**Standard Permit for Solid Waste Landfill
Granite State Landfill – Phase I
Response to NHDES Incomplete Application (#2021-52265)
Douglas Drive
Dalton, NH 03598**

**RE: Granite State Landfill, LLC
Proposed Lined Landfill – Dalton, New Hampshire
Standard Permit Modification – Application # 2021-52265
Response to NHDES Incomplete Application Correspondence**

CMA Groundwater Separation – Wetland Areas

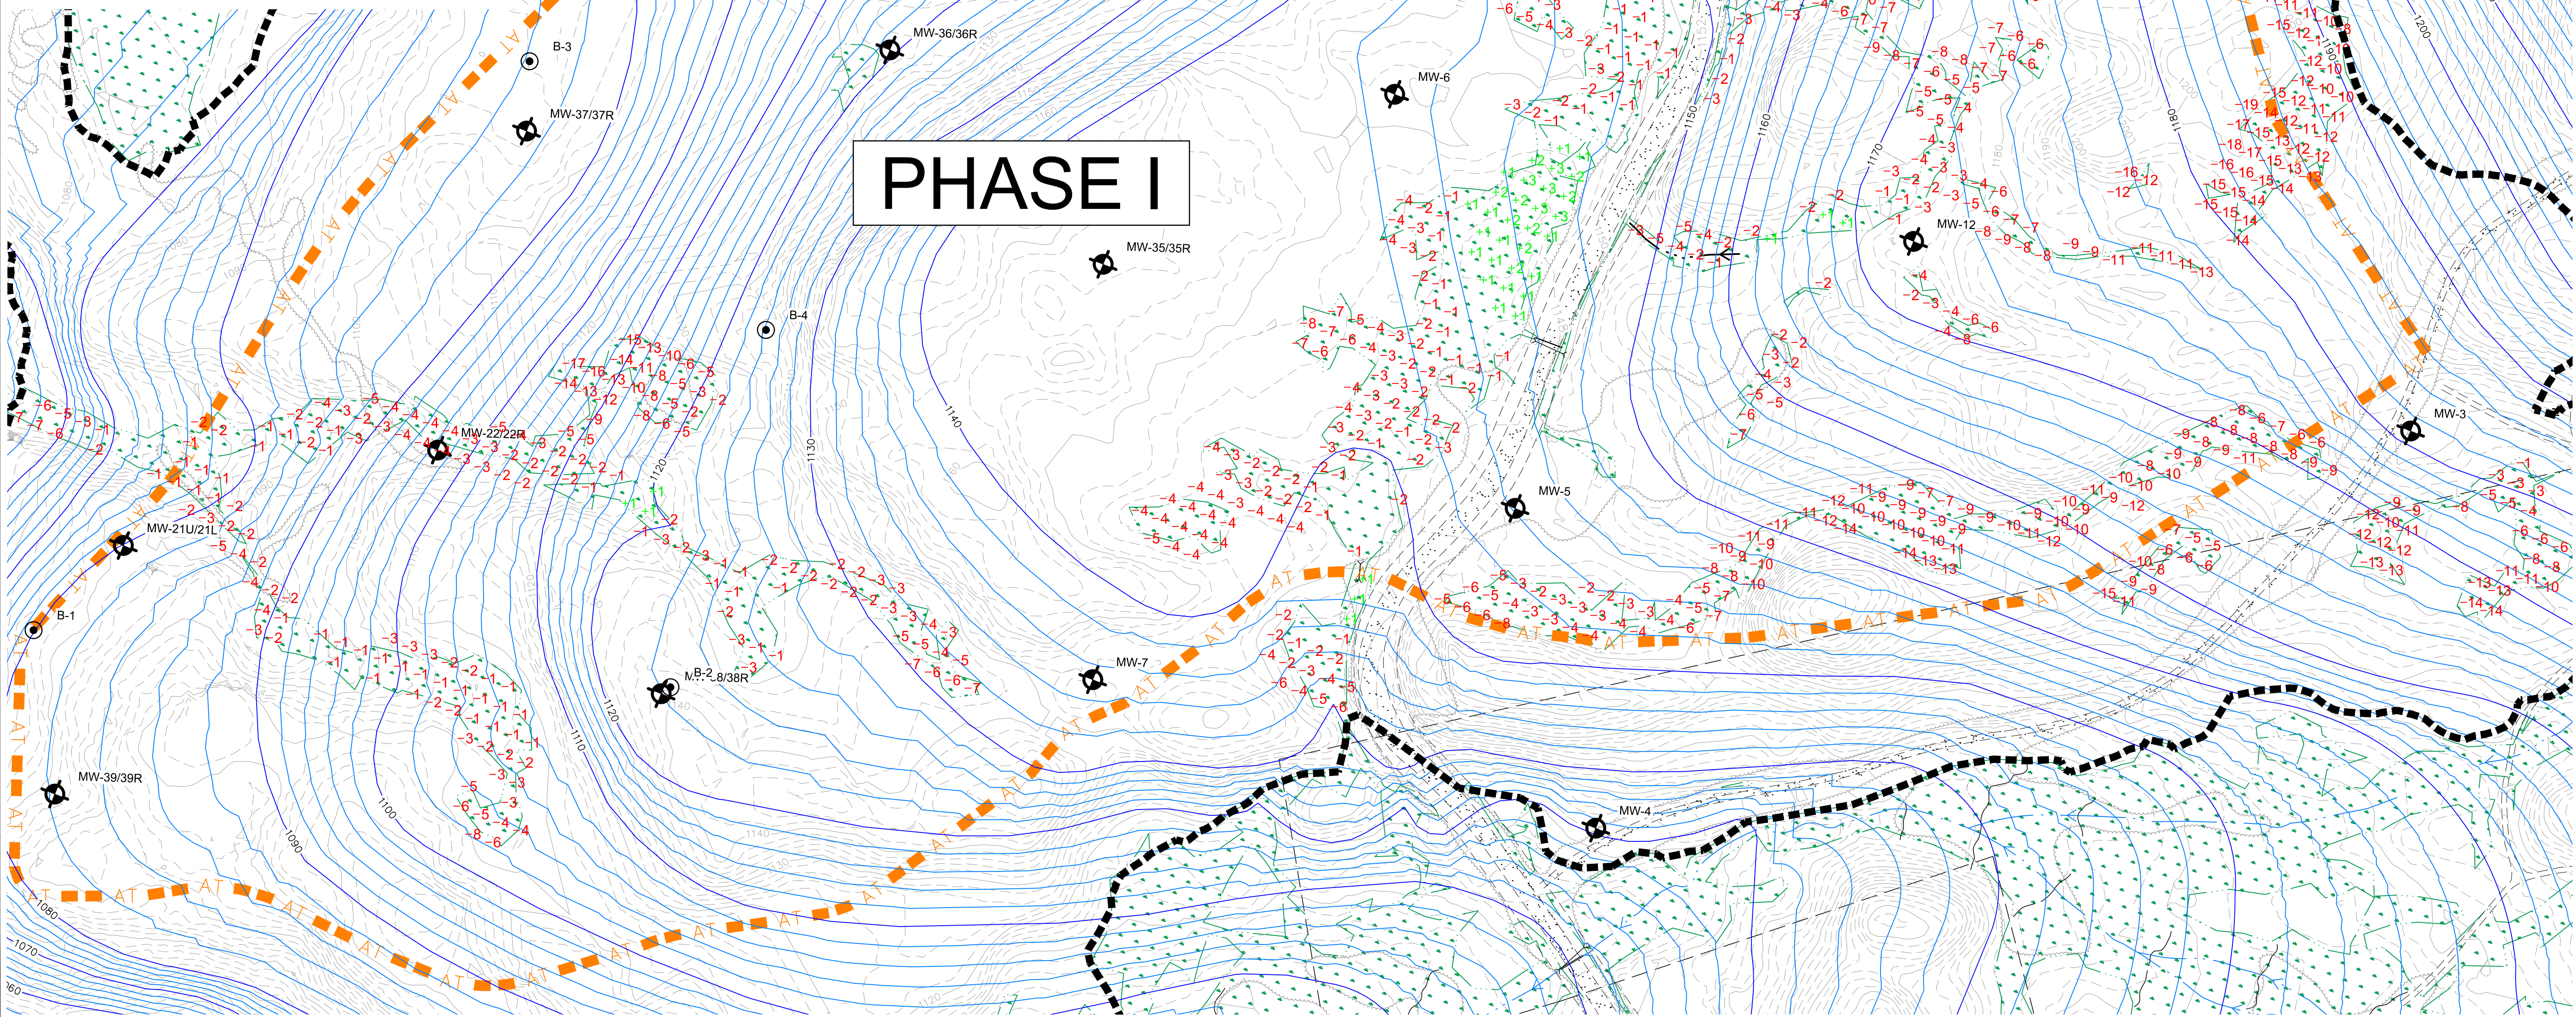
- *A discussion regarding how the discharging groundwater conditions will be affected by potential filling of wetlands, both within the liner footprint and outside of it. Address the potential effects of fill on groundwater elevations and whether it will cause a rise in groundwater levels that may compromise the required 6-foot groundwater to liner separation.*

The GSL engineering team has evaluated the delineated wetlands within the Phase I limits of disturbance and their vertical position relative to seasonal high water levels. See attached figure which compares the seasonal high groundwater contours and the surface topography. Most of the delineated wetlands depict red "tick marks" signifying they are perched above the seasonal high water levels. Note that wetlands within the Phase I area do not contain field-delineated perennial or intermittent streams or ponded surface water indicating they do not receive significant discharging groundwater flows. In October 2021, piezometers were installed in select Phase I wetlands to further refine measurement of groundwater elevations in wetland areas. This information will be reported in a future Hydrogeologic Supplement.

Most of the wetlands will be filled during construction of the first five of seven landfill cells. These wetland soils will be removed, backfilled, and covered with the landfill subbase soils and lining system as construction progresses. The landfill lining system will block and collect recharging precipitation infiltration resulting in lower groundwater levels. The wetlands in the last two landfill cells will be filled several years before cell construction during the latter years of the expected 10-year term of the Alteration of Terrain (AoT) permit (five-year permit and expected five-year extension). These wetland soils will be removed, backfilled with granular fill, compacted and graded to promote sheet flow and infiltration of precipitation. Upslope diversion swales will divert surface water run on to storm water ponds and away from the filled wetlands to prevent re-establishment of wetland conditions. No soil/rock drains or drain piping is proposed to artificially depress water levels in any wetland areas.

Figure 11

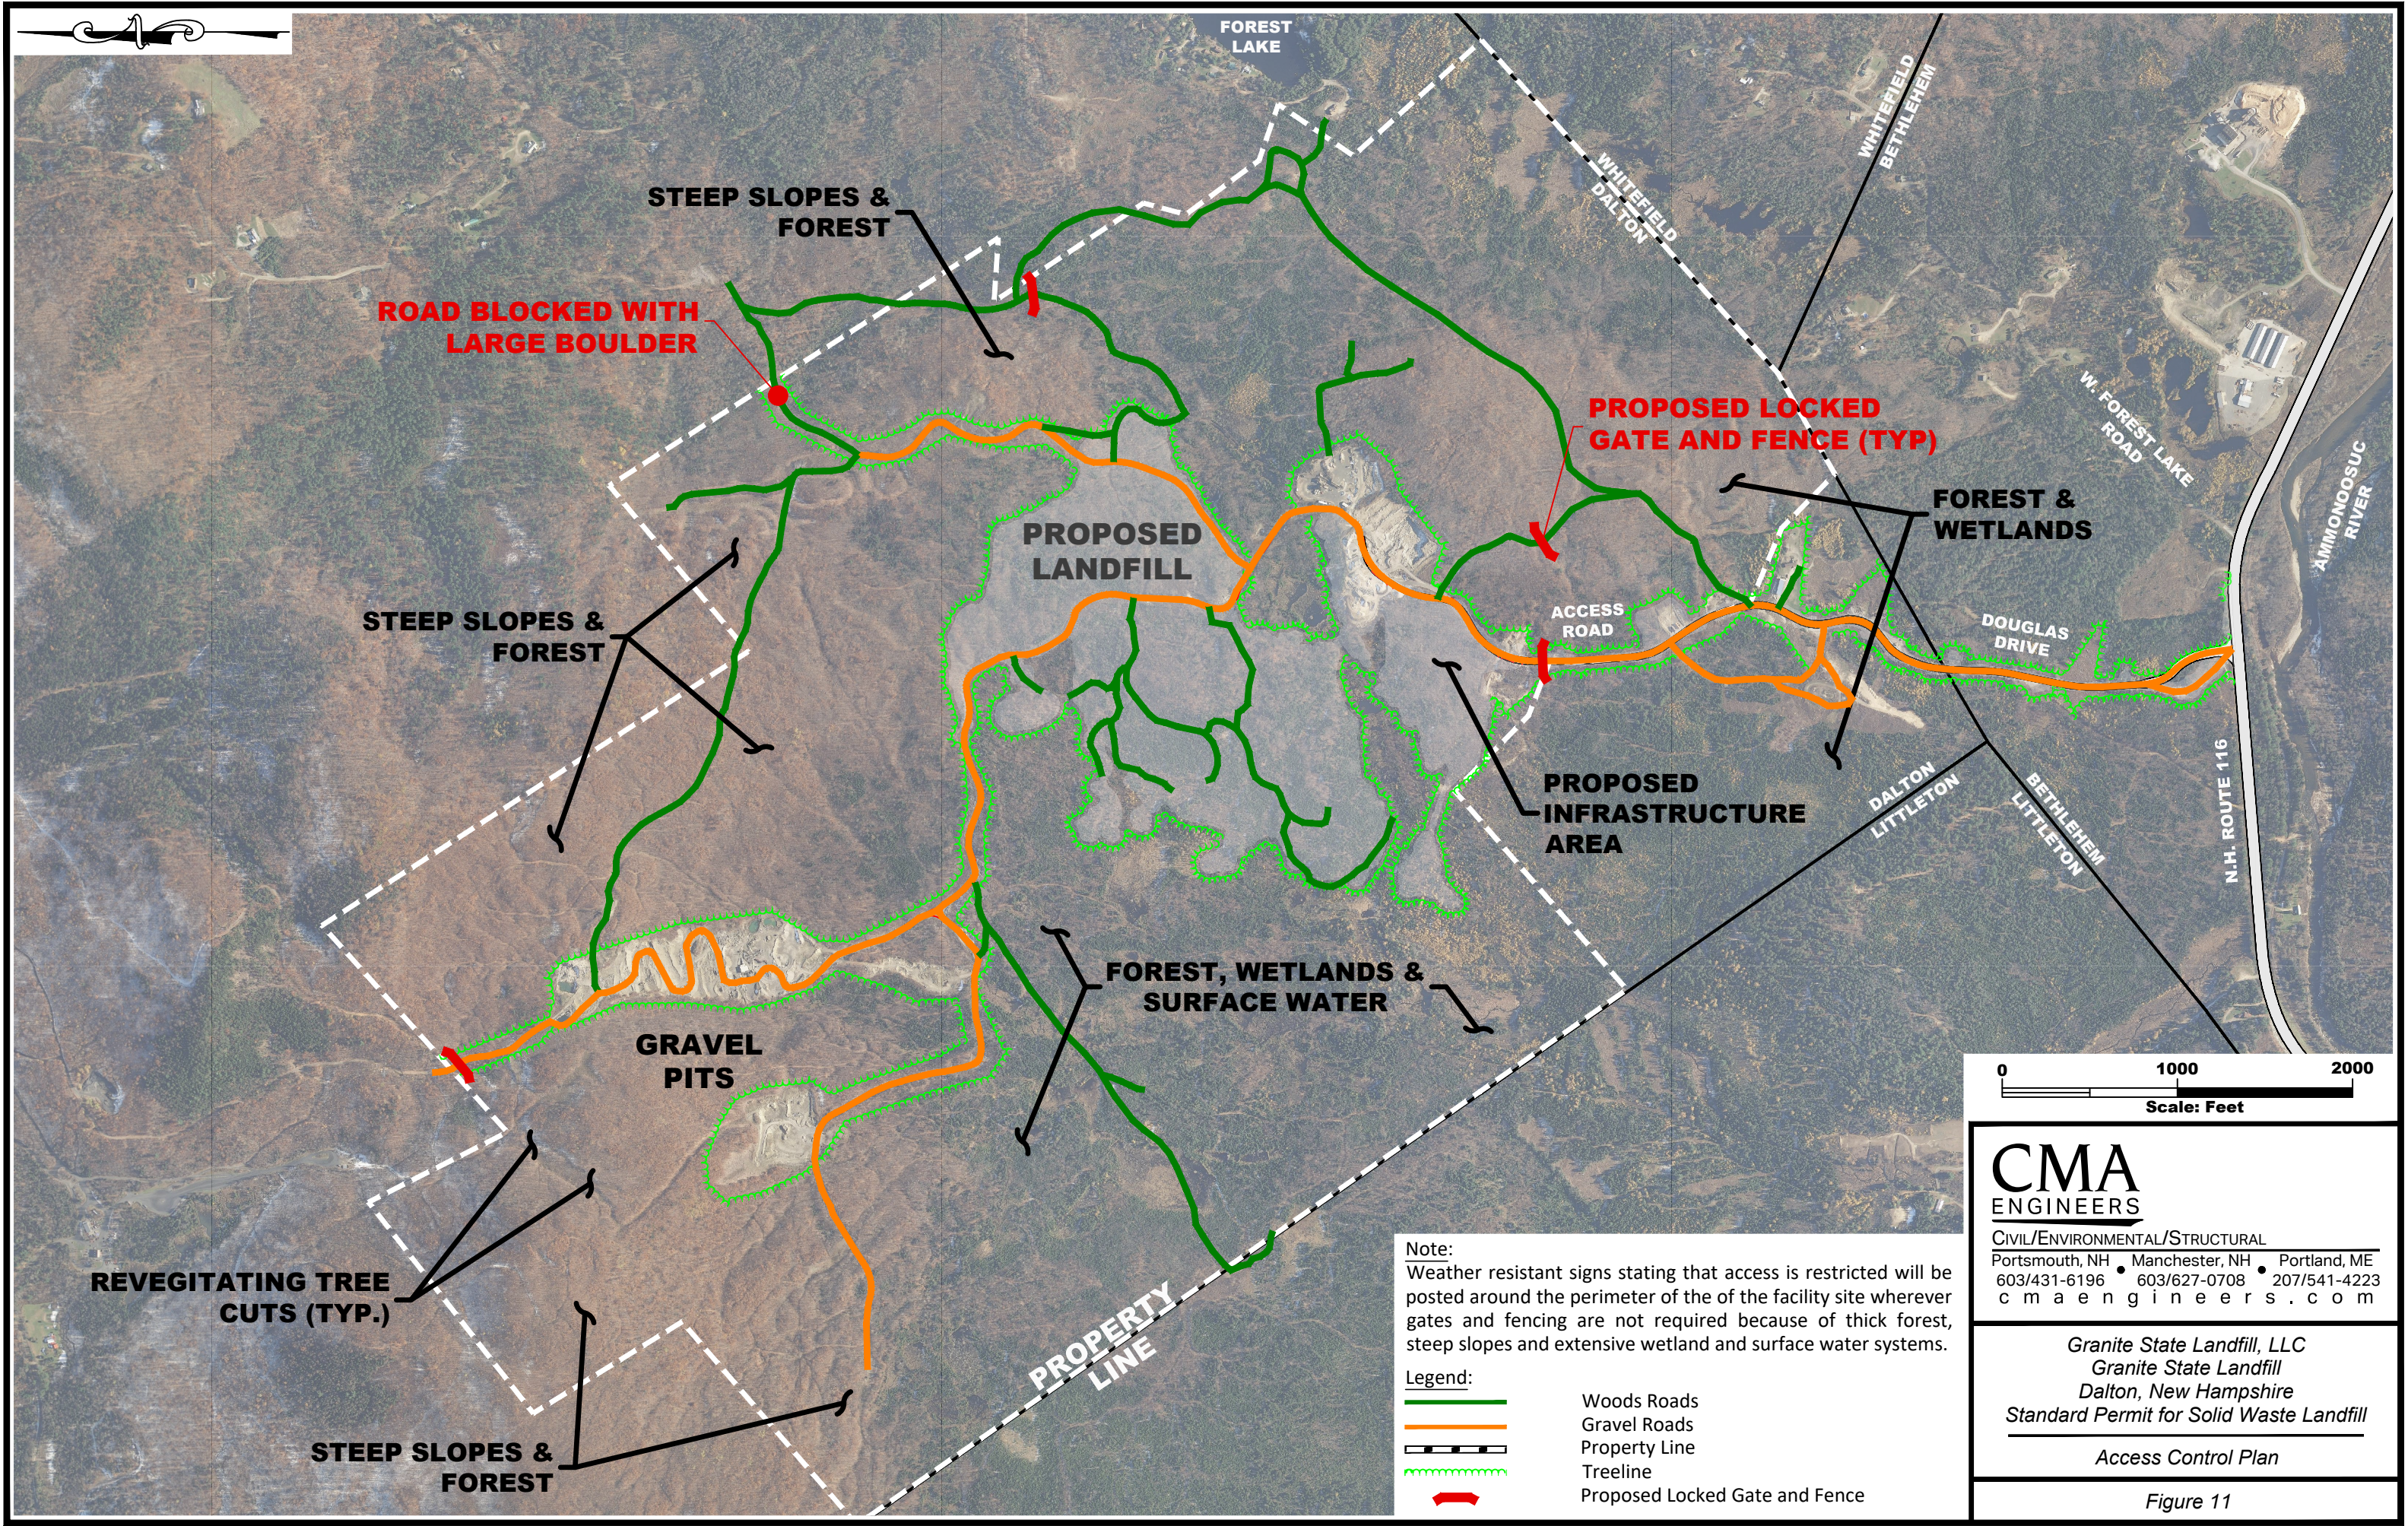
The application indicates that fencing will be used to control access; however, fencing for access control could not be identified on the proposed plans. Clarify where fencing will be used to provide access control. In addition, NHDES is aware

that a number of access roads have historically crossed the proposed property boundaries. Provide a review of and proposed controls for these corridors as needed to meet the requirements of Env-Sw 1103.03.

GSL provides a revised figure as prepared by CMA Engineers that considers a complete field reconnaissance and depicts the existing and any proposed conditions for perimeter security at the site.
